Draft decision

United Energy electricity distribution determination

Attachment 3 – Operating expenditure

September 2025

Figure 3.1 Historical and forecast opex (\$million, 2025–26)

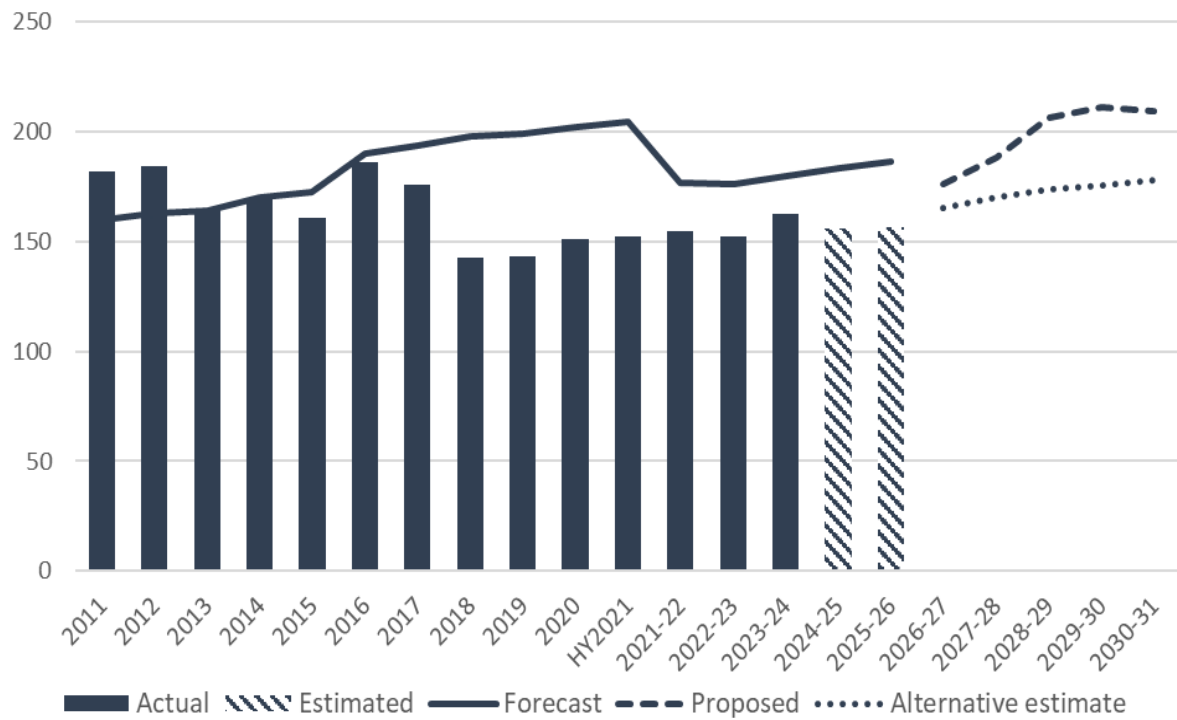
Our draft decision is to not accept United Energy's total opex forecast of \$990.8 million,¹ including debt raising costs, for the 2026–31 period.² This is because our alternative estimate of \$861.8 million is materially different (\$129.1 million, or 13.0% lower) than United Energy's total opex forecast proposal. Therefore, we consider that United Energy's total opex forecast does not reasonably reflect the opex criteria.³

- \$37.6 million (–4.2%) lower than the opex forecast we approved for the 2021–26 regulatory control period (2021–26 period)
- \$81.9 million (10.5%) higher than United Energy's actual (and estimated) opex in the 2021–26 period.

In Figure 3.1, we compare our alternative estimate of opex to United Energy's proposal for the next regulatory control period. We also show the forecasts we approved for the last 2 regulatory control periods, and United Energy's actual and estimated opex over these periods.

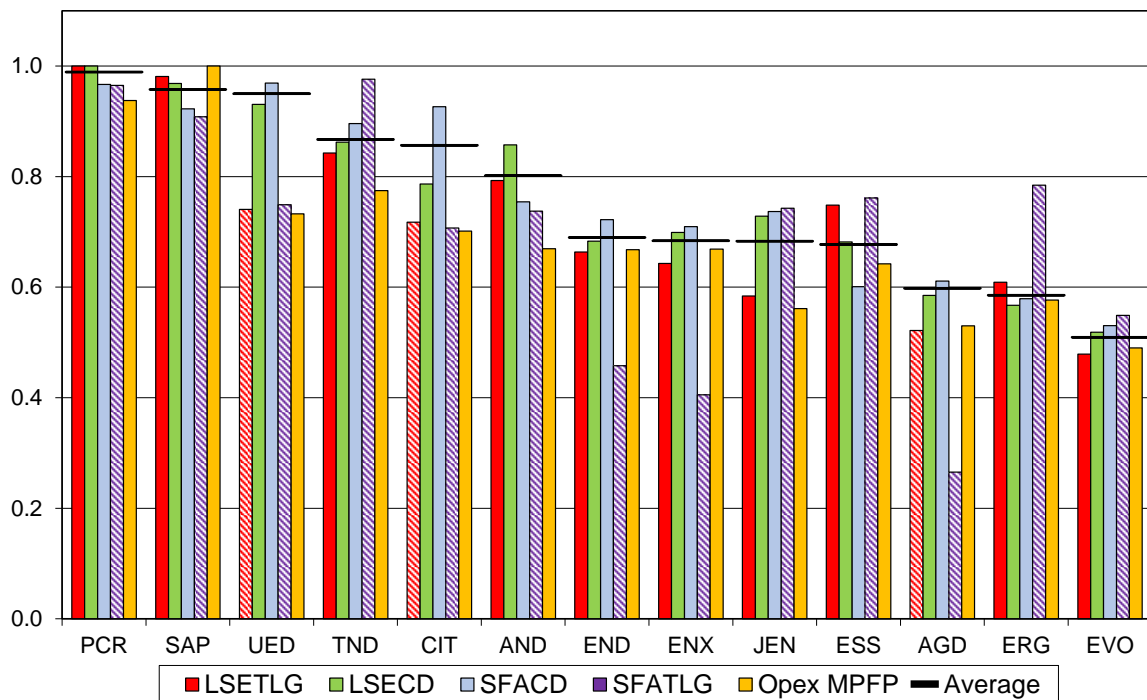
In terms of the trend in opex, Figure 3.1 shows United Energy's opex forecast for the next regulatory control period, its actual opex in previous regulatory control periods and our previous regulatory decisions.

Overall, United Energy's opex has been historically lower than our approved forecast since 2015–16. United Energy's estimated opex in the base year (2024–25) of \$155.8 million is \$26.9 million (–14.7%) below the approved forecast opex for that year.

Figure 3.6 United Energy's vegetation management opex (\$million, 2025–26)

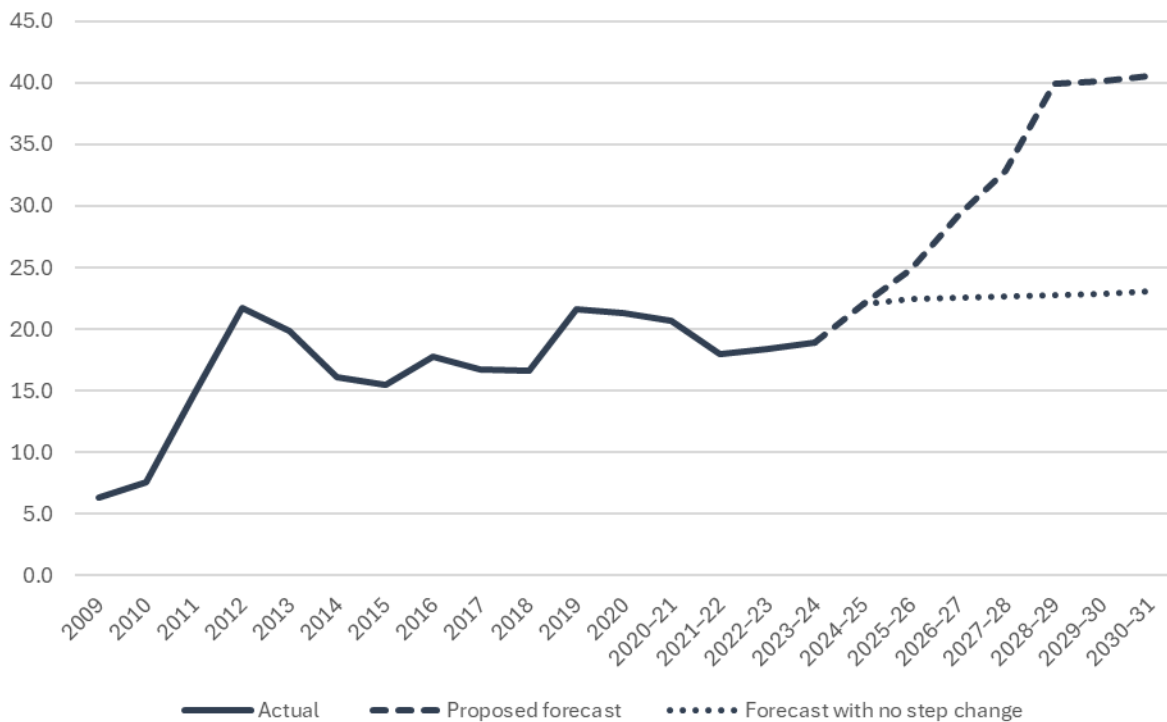
We note that United Energy’s vegetation management opex rose significantly from 2011, as shown in Figure 3.6. This followed a significant increase in its obligations imposed following the Black Saturday bushfires in 2009. From 2013, United Energy reduced its vegetation management opex. After introducing its LiDAR program, and identifying significant

United Energy's forecast vegetation management opex for the 2026–31 period is 79% more than its actual and estimated vegetation management opex for the 2021–26 period, and 94% more than the 2016–2020 period.

Without a step change, base year vegetation opex, plus the rate of change, would provide United Energy 11% more than its actual and estimated vegetation management opex for the 2021–26 period, and 21% more than the 2016–2020 period.

Figure 3.7 LBRA spans cut and remaining, 2023 to 2024

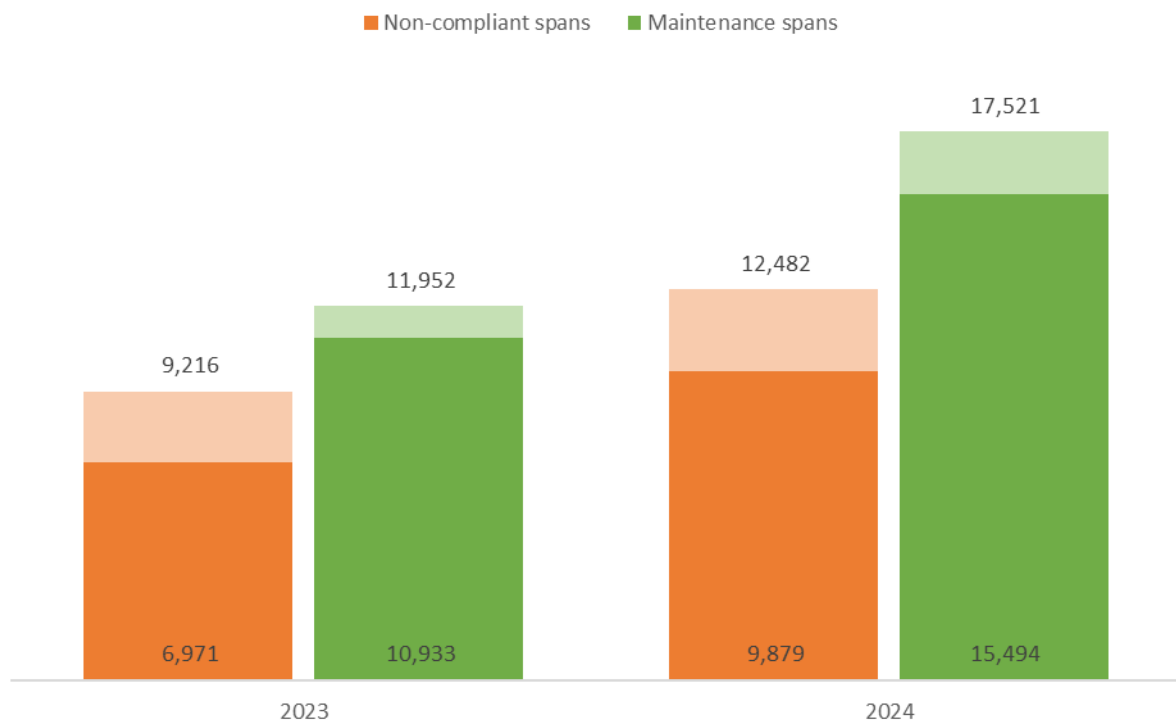
We consider United Energy has already significantly improved its compliance in its HBRA areas, which it has prioritised. It is less advanced in its low bushfire risk areas (LBRA). In Figure 3.7, we show the number of cuts made and the remaining non-compliant spans in its LBRA areas. We can see that United Energy had more cuts remaining at the end of 2024. The darker shaded columns in the stacks represent the cuts made. The lighter shaded columns reflect the spans that remained uncut at the end of the year.
